## **BUTTE-SILVER BOW ZONING BOARD OF ADJUSTMENT**

**Thursday, August 4, 2016, at 5:30 P.M.**

**BUTTE-SILVER BOW  
ZONING BOARD OF ADJUSTMENT  
STAFF ANALYSIS**

**ITEM:** Variance Application #15181 - An application for a variance to create two parcels of record of substandard size from two legal nonconforming lots of record. One lot is proposed to be 2,621.14 square feet that has an existing garage on the property and the other proposed vacant lot is to be 2,222.79, varying from the requirements of Section 17.12.050, Minimum Lot Area, and the proposed lot of 2,621.14 square feet is also varying from the definition of "Lot" which requires each lot to have frontage on a public street varying from Section 17.04.245, Lot, of the BSBMC.

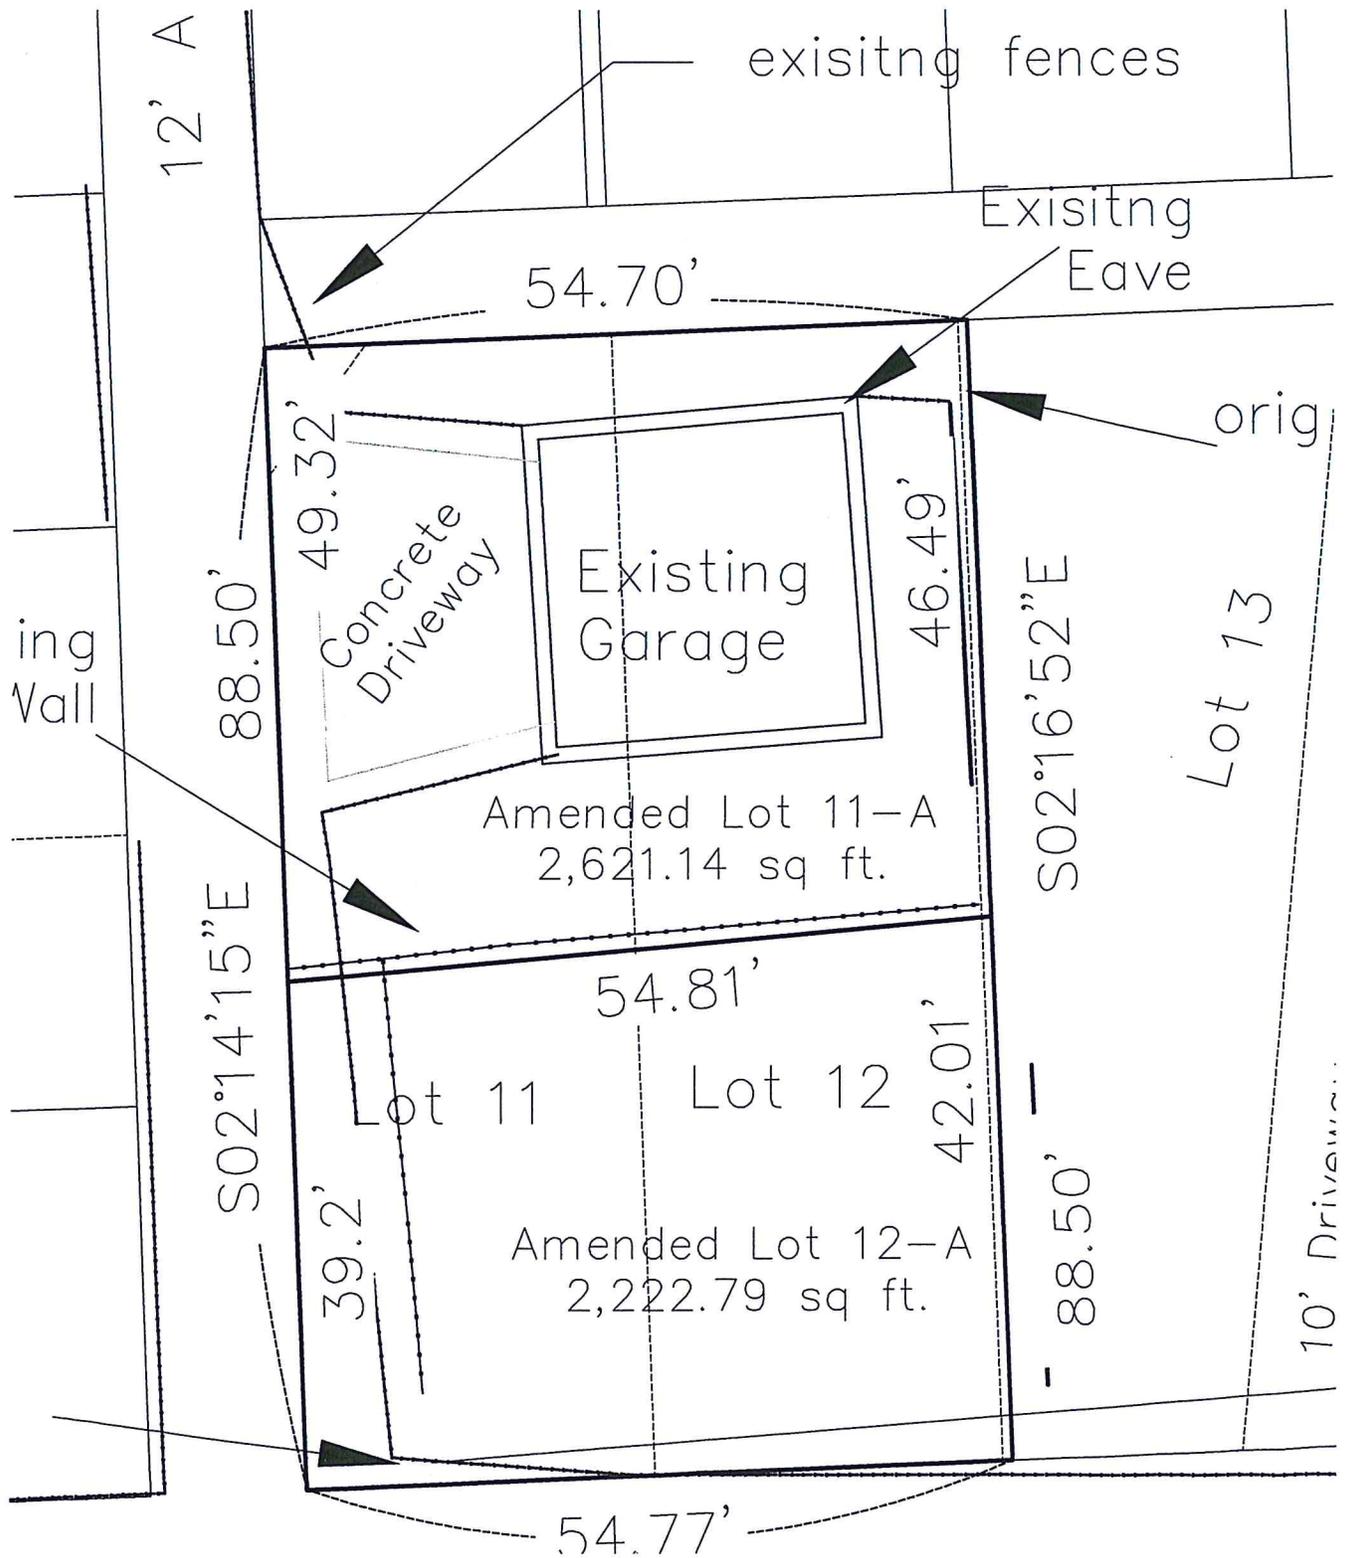
The applicants' request to create two substandard parcels from two nonconforming parcels would be akin to a boundary line readjustment, and in fact, not significantly changing the square footage of the lots, simply changing their orientation. The main concern with respect to public health, safety and general welfare lies in the creation of a parcel that would have no public street access. Generally, a request of this nature void of additional circumstance or information would not be supported by staff.

reestablish a handshake agreement between neighbors following the passing of one party. All parties involved seemingly agree on the fact that, if established, the new parcels are designed to exist as accessory parcels to the associated residences along North Main Street and are not intended to be sold as separate lots from the primary residences. Accordingly, ***if and only if*** the applicants are agreeable to a condition which requires the applicants to amend their deeds for the properties located on Main Street to include their respective lots across the alley, then the granting of the requested variance ***will not pose*** any detriment to public health, safety, and general welfare, but will only make it easier for the applicants to sell the property. The amended deed language shall restrict the sale of the proposed lots separately from the primary residence parcels located on Main Street. Therefore, staff would conclude that this variance request complies with the intent of the Zoning Ordinance to allow for the reasonable use of private property.

1. Receiving approval to create two (2) substandard parcels of record is only the first step in creating two (2) new legal parcels. In order for the applicants to divide the property, the applicants shall complete a relocation of common boundary survey for review and approval. Upon approval from the Examining Land Surveyor, the applicants shall file the Certificate of Survey and appropriate deeds with the B-SB Clerk and Recorder.

2. The applicants shall amend each deed for the properties located on Main Street to include their respective lot across the alley. The amended deed language shall restrict the sale of the proposed lots separately from the primary residence parcels located on Main Street.
3. The deeds shall be filed in conjunction with the Certificate of Survey with the B-SB Clerk & Recorder.
4. Any further development on the newly created substandard lots shall abide by the regulations of the Butte-Silver Bow Zoning Ordinance.
5. Any deviation or change from the terms and conditions of Variance Application #15181 must be brought before the Zoning Board of Adjustment.

**313 E. Front**  
Historic Preservation Officer Assessment of Stope Removal  
July 27, 2016

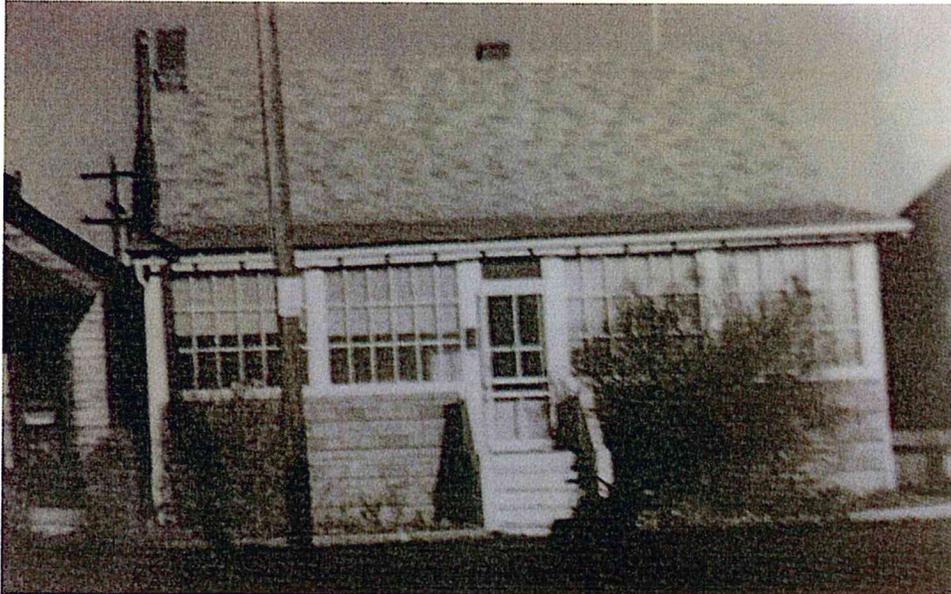
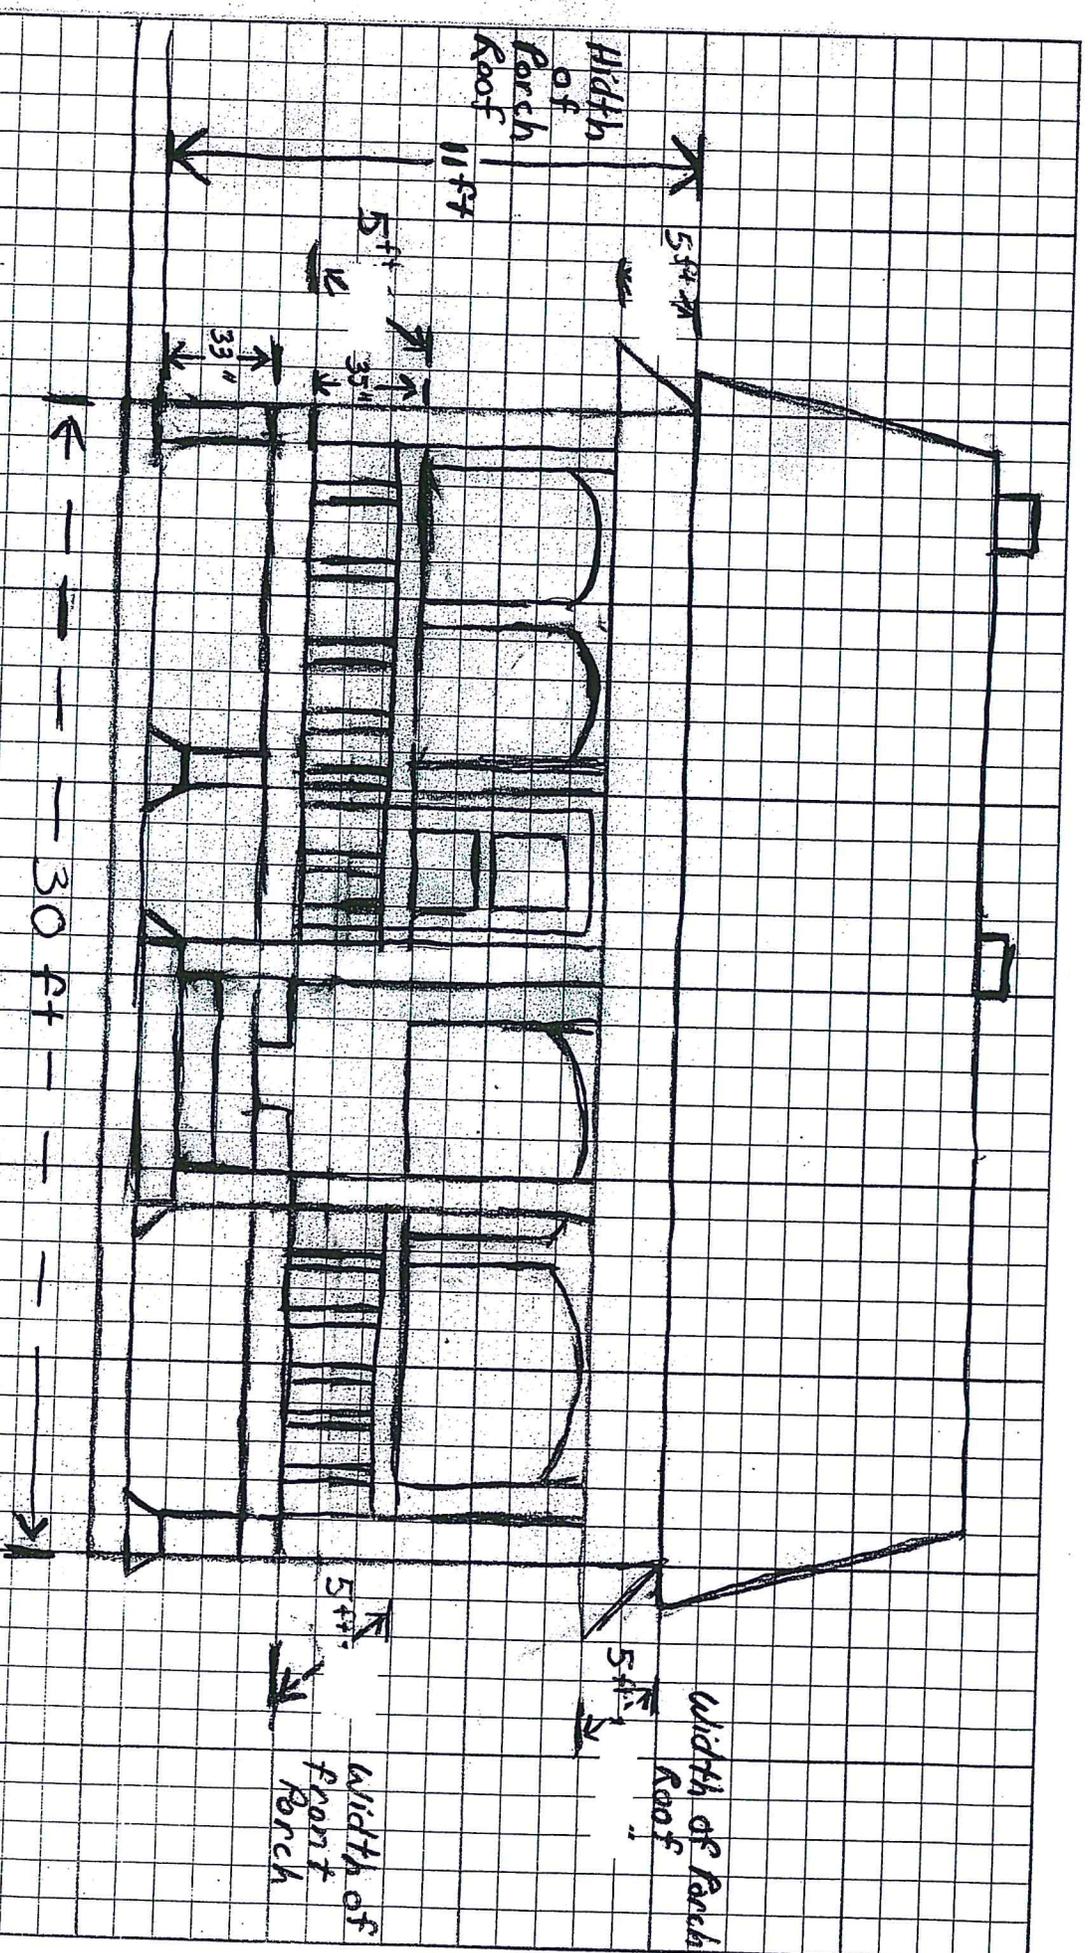
The site plan submitted for this variance details front porch access stairs that are in fact, set into the porch, and not encroaching on the public sidewalk or right-of-way.

A final area of concern regarding a zero foot (0') setback along East Front Street would be with regard to storm water. As the roof over the porch would slope southeast towards East Front Street and

there is no permeable area to detain any storm water that may run off of the roof of the residence and porch, special measures would need to be taken to ensure that storm water is detained on his property and does not create safety concerns on the public sidewalk.

The owner is proposing to remove the wooden stope at the front entry and construct a full-length open porch on the front façade—which is the historic front porch, now enclosed. He would like to extend the new porch to the sidewalk.

The existing wooden stope is a small, non-historic element built sometime after 1959. There is no requirement for the Historic Preservation Commission to review and approve a Demolition Permit COA prior its removal.

1. The applicant shall secure all necessary permits from Butte-Silver Bow and shall abide by all other regulations of the Zoning Ordinance.
2. The applicant shall work closely with the Butte-Silver Bow Planning Department and the Butte-Silver Bow Historic Preservation Officer to ensure that the demolition of the porch in question at no time expands beyond the criteria which would initiate necessity of HPC review.

3. The applicant must agree not to utilize any portion of the public right-of-way of Front Street for the construction of the proposed porch, including but not limited to removal of any portion of the sidewalk. If encroachment upon public right-of-way is unavoidable, a Construction Right-of-Way Permit must be applied for prior to the commencement of construction.

4. The applicant shall install rain gutters on the roof of the porch to ensure that all storm water is directed, so that it will remain on his property.

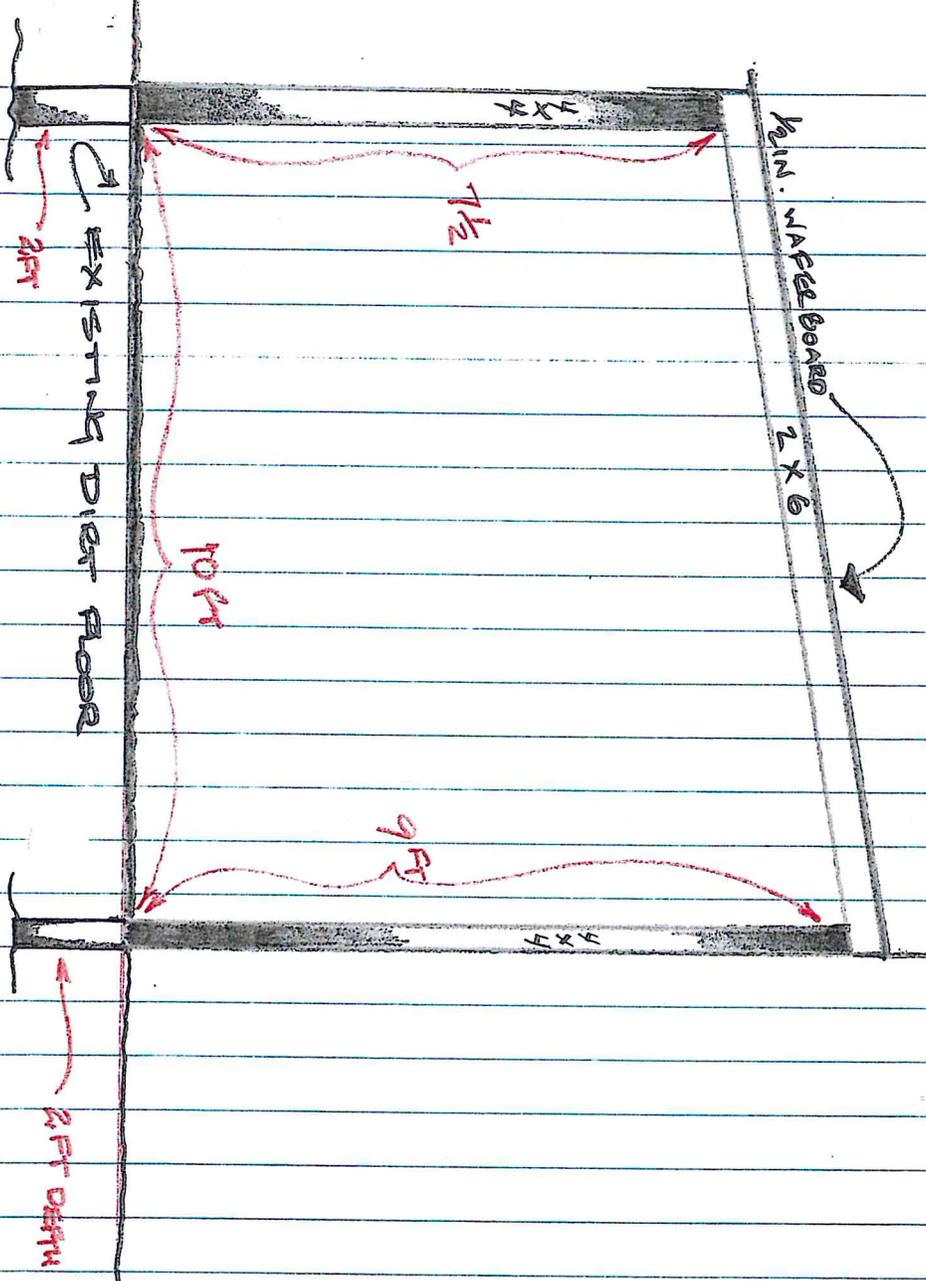
The lean-to carport structure is 10'W x 24'D and has been constructed by extending the garage roof line west approximately ten feet (10'). The roof is supported by the use of 4" x 4" posts. As such, the west wall of the garage would act as the east side of the carport with the remaining north, west and south sides left open. In this particular case the design of the carport is important in that the west alignment, which is the lowest side of the roofline, is immediately adjacent, i.e., within one foot (1') to the

The main issue in considering this variance is storm water management: the roof of the lean-to structure has a westward-dipping slope and overhangs its supporting posts by approximately three inches (3"). Without proper controls, storm water from the lean-to carport could be detrimental to the neighbor's fence and property along the shared boundary. As such, should the Board vote to approve the variance, a condition of approval should require the applicants to install rain gutters along the west edge of the roofline to prevent storm water runoff from reaching the neighbors' property.

In this particular case, the applicants are requesting a side yard setback variance within one foot (1') of the property line (vs. three feet (3') off an alley in the rear area of the property), which has potential to negatively impact their neighbor to the west. Storm water concerns, in particular, and adverse impacts to the neighbors' fence must be addressed. In fact, it

1. Within five working days of the public hearing for Variance Application #15195, the applicants shall submit the construction plans for the carport to the Butte-Silver Bow Building Official for verification that construction was completed in compliance with all applicable building, electrical, mechanical, fire and health codes.
2. Within five working days of the public hearing for Variance Application #15195, the applicants shall submit a plan for staff review and approval to ensure

that the storm water generated from the carport does not drain onto or adversely affect his neighbor's property or into the public alley. At a minimum, the plan shall specify gutters along the west edge of the roof and appropriate well-directed downspouts to ensure all storm water generated from the garage and lean-to carport is retained on the applicants' property and away from the neighbor's and public property. The storm water control measures outlined in the plan shall be installed within 15 working days of staff approval of the plan.
